NUCLEAR ENERGY INSTITUTE

SUBJECT: Steam Generator Degradation Specific Management Database,
POPCD Corrections in Addendum 3

PROJECT NUMBER: 689

**Revised Section 7
To the
SGDSM Database, Addendum 3**

Figure 7-2
Combined POPCD Evaluation for 15 Post-92 Inspections for 7/8" Dia Plants
POPCD Based on RPC Confirmed Plus Not Inspected Indications

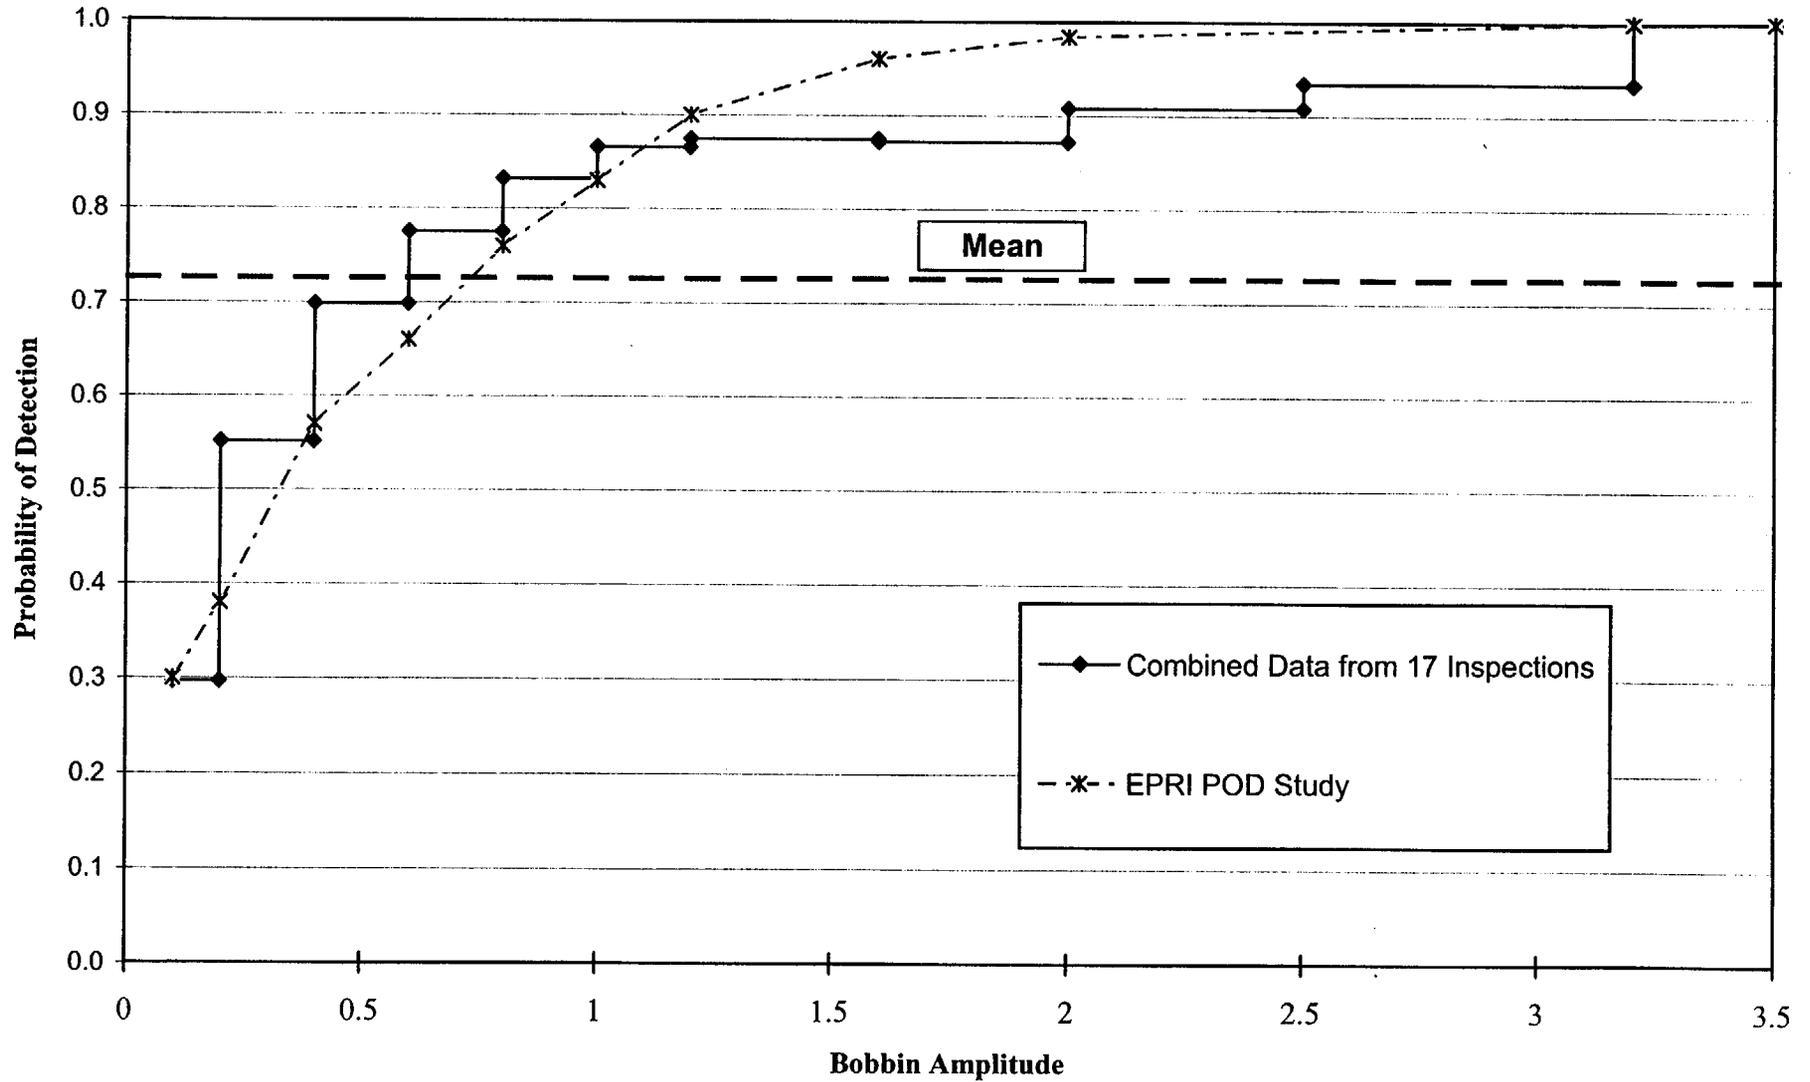
The error in the Addendum-3 POPCD update involved duplication of the data for 2 inspections in 7/8" tubing plants. So, instead of 6 additional inspection data points for 7/8" tubes, this update should only include data for 4 inspections. Westinghouse has NOT used the Addendum-3 POPCD data in any tube integrity analysis, and we are not aware of anyone else using the Addendum-3 data.

Figure 7-2 (data of Table 7-2) shows the updated POPCD data for plants with 7/8" diameter tubing. It is based on results from 15 inspections performed since 1992. The number of indications considered in the evaluations has increased by about 35% with the addition of data from 4 more inspections. The updated POPCD values show a slight improvement in all voltage ranges except for 0+ to 0.4 and 1.6 to 2 volt bins. Indications in the size range 0+ to 0.4 volts do not contribute significantly affect tube integrity and, therefore, a modest decrease in POPCD for such indications is inconsequential. The POPCD value for the 1.6 to 2 volt bin decreased by about 0.02, and a change of this magnitude is not significant. The average POPCD independent of voltage remained unchanged at about 0.72 with the addition of new data. As with the original data in Addendum-1 and the subsequently updated data in Addendum-2, the presently updated data also support a POD approaching unity above 3 volts.

Figure 7-3
Combined POPCD Evaluation for 23 Post-'92 Inspections
POPCD Based on RPC Confirmed Plus Not Inspected Indications

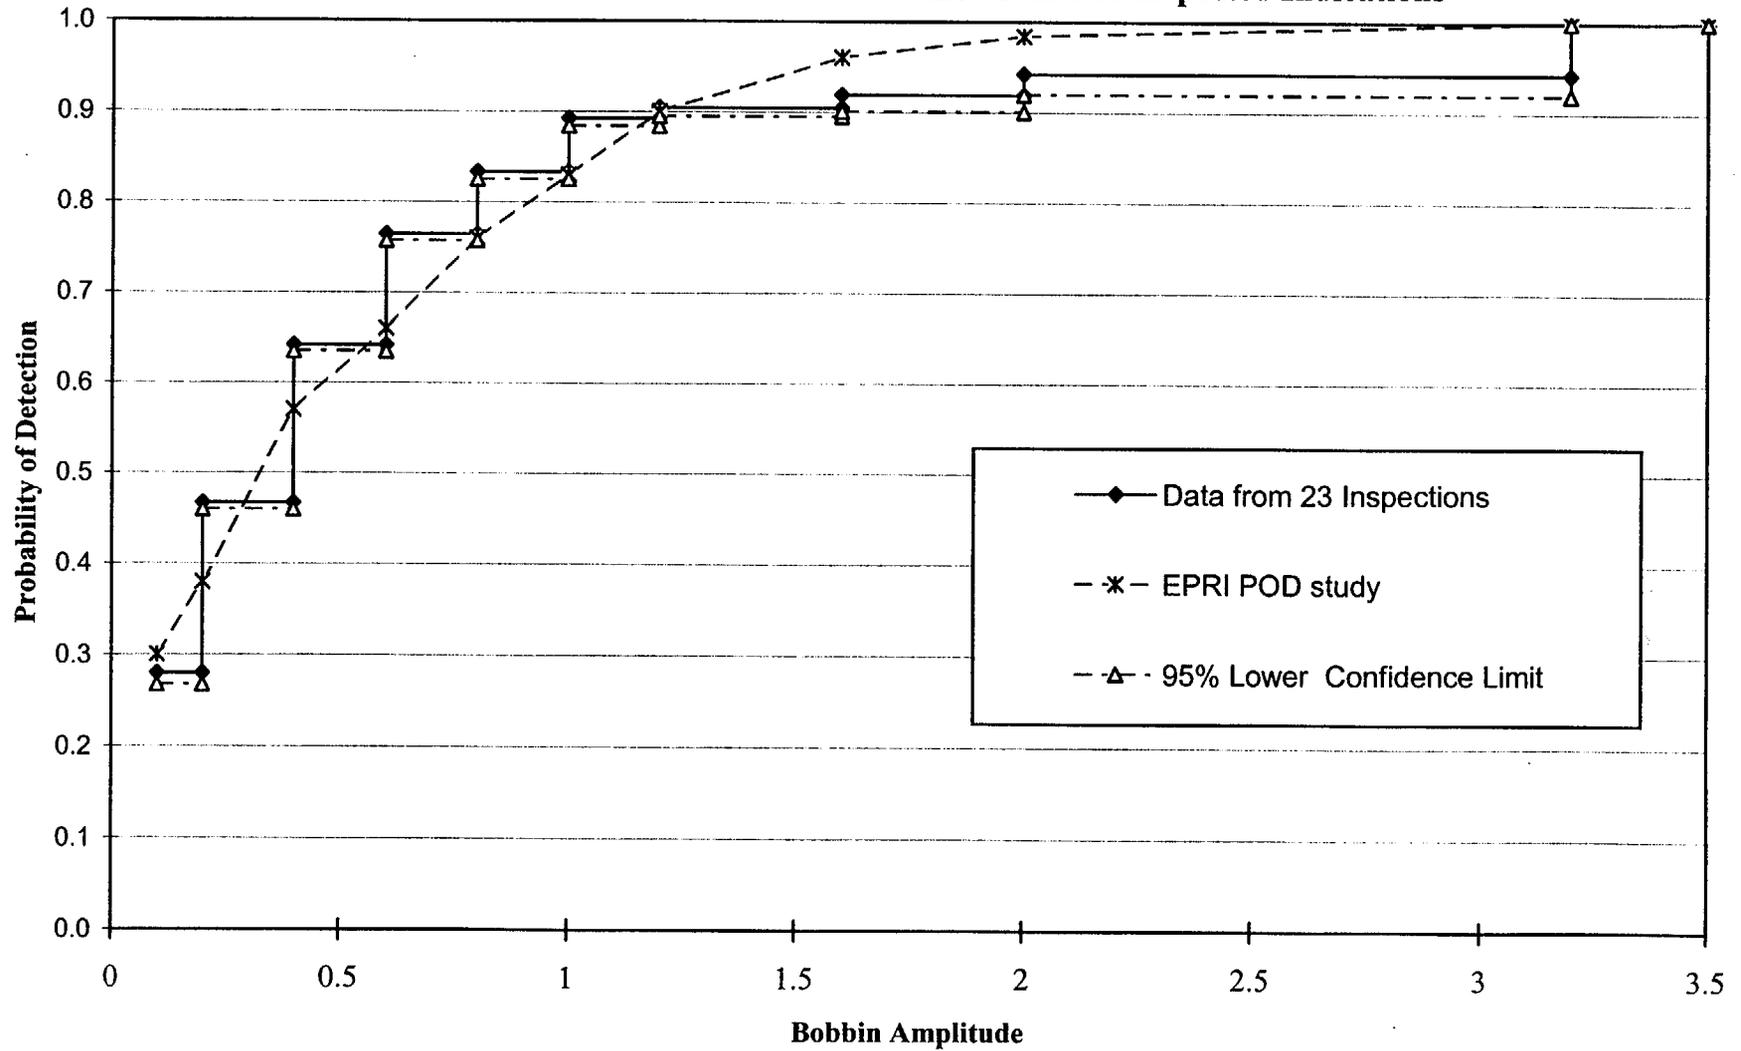
The combined POPCD data for 23 inspections since 1992 are given in Table 7-3, and the results based on the RPC confirmed plus not inspected indications are illustrated in Figure 7-3. The updated POPCD distribution is very similar to the distributions shown in Addenda-1 and 2. It is also in good agreement with an EPRI POD developed using multiple analysts to evaluate a large number of field indications with "truth" for indications based on "expert" opinion. POPCD supports a POD approaching unity at about 3.5 volts while the EPRI POD is about 0.98 at 2 volts and unity at 3 volts. Figure 7-3 also includes POPCD evaluated at the lower 95% confidence limit on the data for individual voltage bins. The data of Table 7-3 show 741 to 13,920 indications in all voltage bins below 2 volts, nearly 417 between 2.0 and 3.2 volts and about 66 indications above about 3.2 volts. Thus, the collective data provide a substantial database for defining a POD.

As with the data presented in Addenda-1 and 2, the results of Figure 7-3 clearly support an increase in the POD for voltage-based repair criteria applications above the $POD = 0.6$, independent of voltage, required by the NRC Generic Letter 95-05. For indications above 1.0 volt, the POD exceeds 0.85 and is 0.92 to near unity at 2.0 volts. A POD of 0.6 is only applicable to indications below about 0.5 volts.
